Addendum #002

April 28, 2026

New Jetson Center for Youth
Baker, Louisiana
Project # 08-403-04-02, F.08000078, 08-403-24-01, F.08000165

ELECTRICAL POWER PLAN - SECTOR B

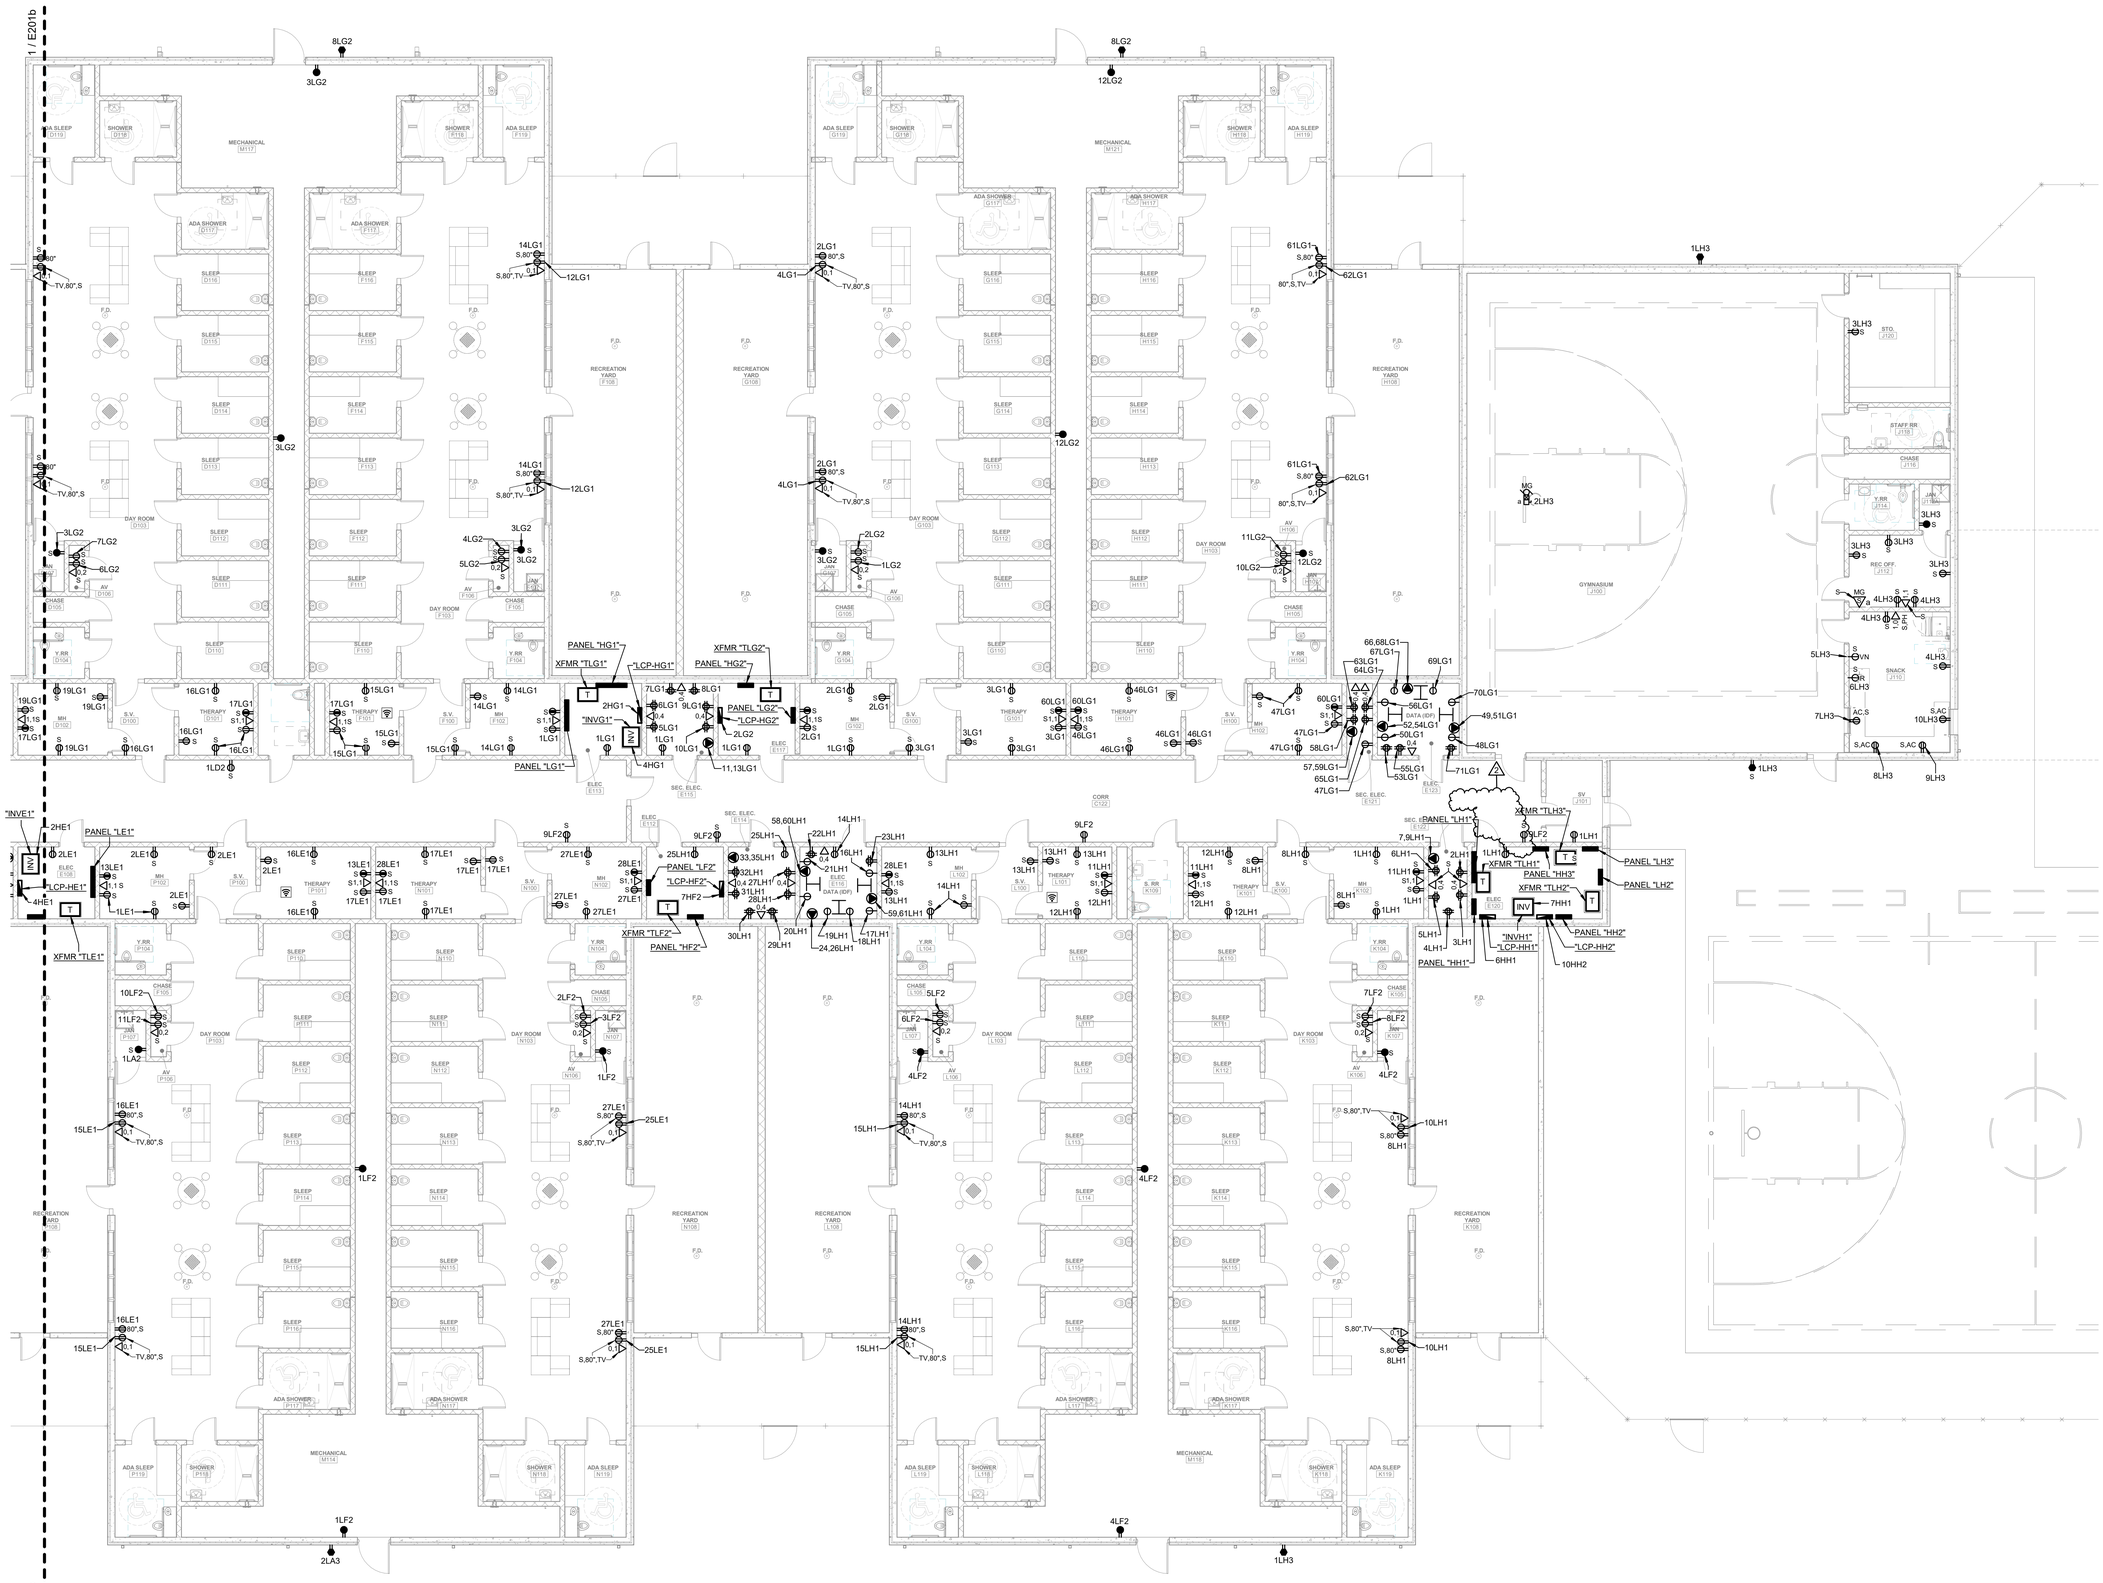
a. Make changes to the “Electrical Lighting Plan - Sector C” as shown.
6. **SHEET E201b – ELECTRICAL POWER PLAN – SECTOR B**
    a. Make changes to the “Electrical Power Plan - Sector B” as shown.

SHEET NUMBER
E603

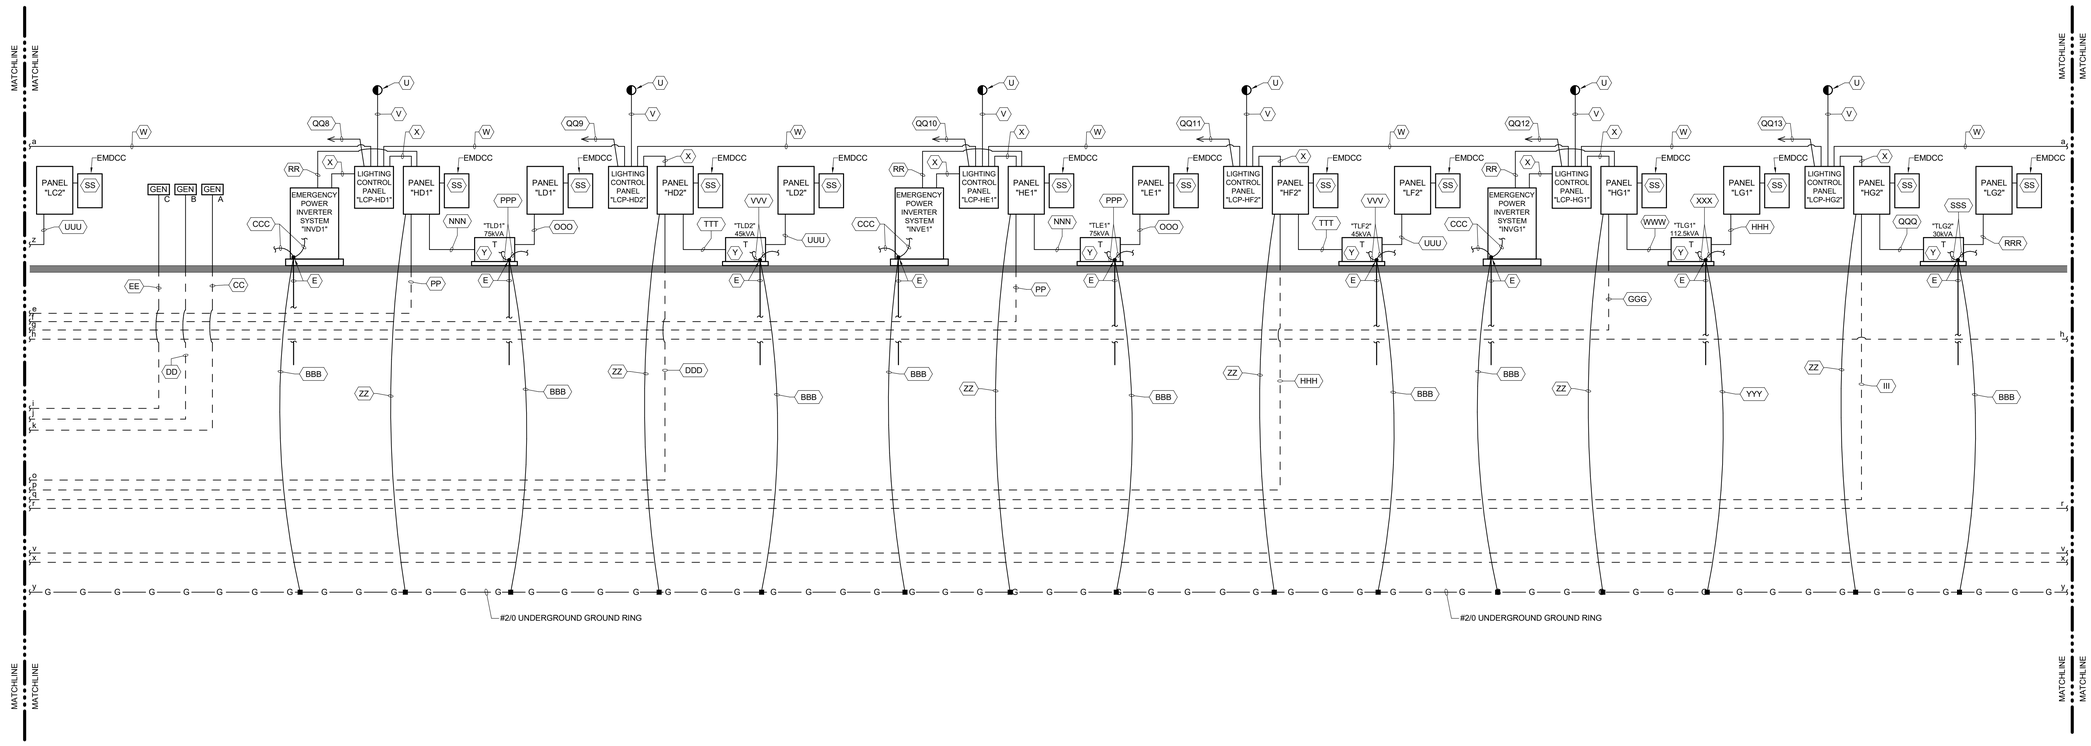
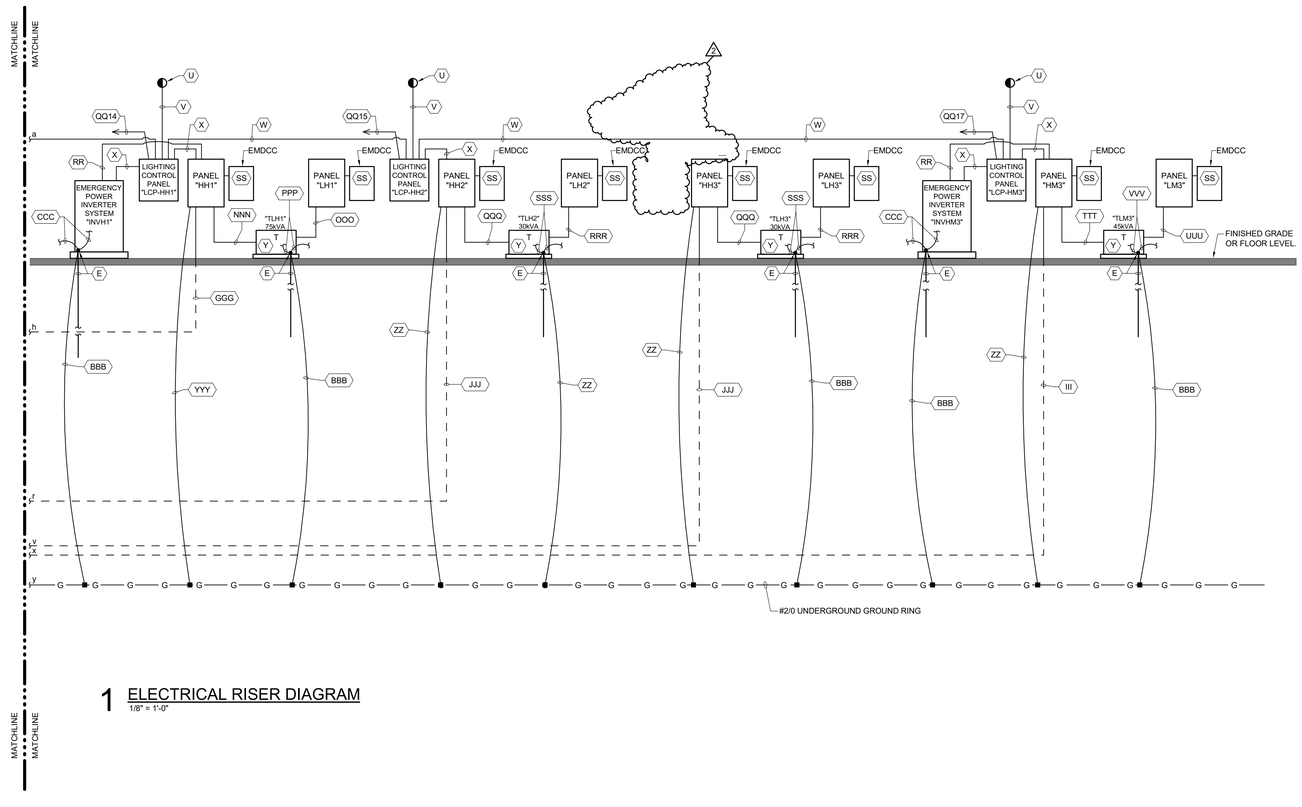
17. **SHEET E603 – ELECTRICAL RISER DIAGRAM**
    a. Note changes to the "Electrical Riser Diagram" sheet as shown.
18. **SHEET E604 – ELECTRICAL RISER DIAGRAM**

1 SEWER PUMP-STATION ELECTRICAL RISER DIAGRAM
3/16" = 1'-0"

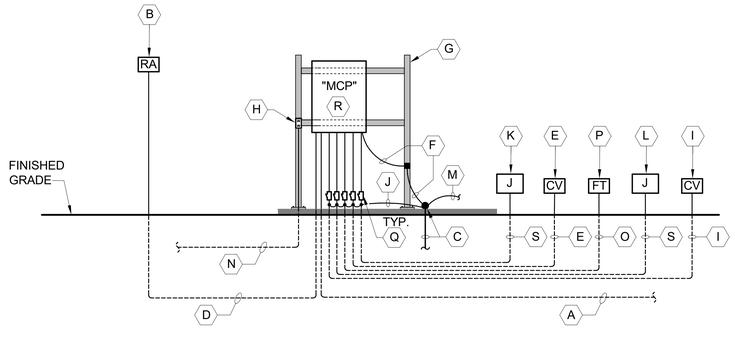
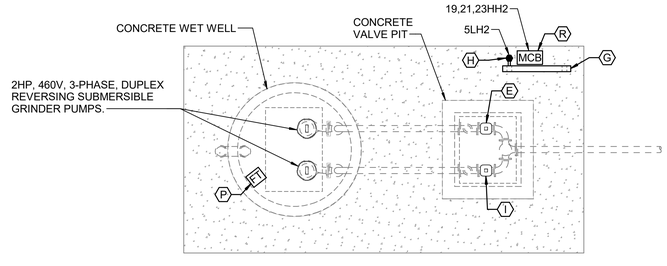
a. Note changes to the "Electrical Riser Diagram" sheet as shown.
19. **SHEET E605 – SEWER PUMP-STATION ELECTRICAL RISER DIAGRAM & SEWER PUMP-STATION ELECTRICAL PLAN**

a. Note addition of new sheet for "Sewer Pump Station Electrical Riser Diagram" as shown.
    b. Note addition of new sheet for "Sewer Pump Station Electrical Plan" as shown.
